## **APPENDIX A:** Annotated Renderings

Appendix B Department	Reviewer	Cycle	Comment #	Comment	Described Described	B
Department	Reviewer	Cycle	Comment #		Drawing/Document	Response
City of Ottawa - Planning	Kersten Nitsche	2	1	The Site Plan and Landscape Plan do not match. The Site Plan shows two vehicular lay-by areas on Miwaře Private to the south of Block 240. An the Site Plan, they appear to conflict with a planter curb and concrete sitting wall (north side of Miwate) and pedestrian light post (south side of Miwate).	N/A (General Comment)	Please refer to updated drawing set - the vehicular lay-by illustrated on the Site Plan has been removed.
City of Ottawa - Planning	Kersten Nitsche	2	2	Please provide a Site Plan and Landscape Plan that does not include the vehicle pathways and turning movements as the linework makes these plans difficult to read. Please shift the vehicle movements to a stand-alone plan that minimizes other linework (e.g., landscaping hatching, etc.) so that those movements are clear and easy to read.		See Architectural Site Plan A101 where turning radii and vehicle pathway linework have been removed. Linework has also been removed from Landscape plans 11.1 an

Annotated Renderings 01: View from Head Street Square facing west

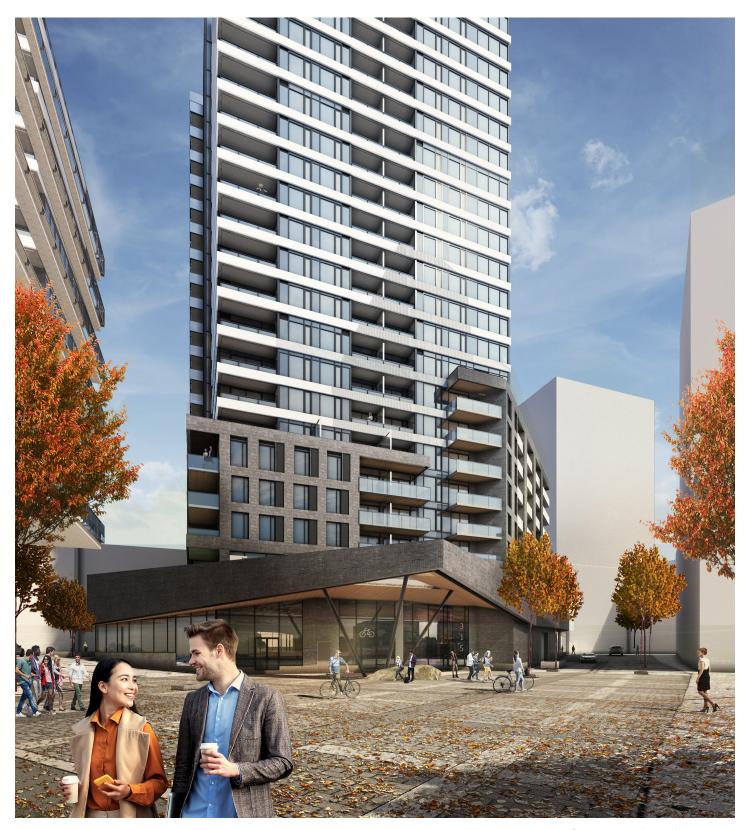
City of Ottawa - Urban Design	The east elevation appears to be an outlier comparing with the other elevations and requires further study. Unlike the other elevations, which are more interesting and successful in expressing the concept of "rock erosion", on the east elevation the east exterior walls of the tower, the podium, and the projected canopy of the ground floor, are parallel to each other, and there is no vertical break on the podium. Could the east elevation be further refined to reflect on the concept of "rock erosion? Considerations may be given to introducing a vertical break on the podium and/or adjusting the shape of the canopy? (see attached diagrams)	31.a	The design team has revisited the east canopy elevation and created a more dynamic shape by raising the mid-point of the masonry canopy fascia along the top edge. This breaks up the consistent horizontal lines to create a more interesting visual from Head Street Square. Please refer to Annotated Renderings 01 included in Appendix A.
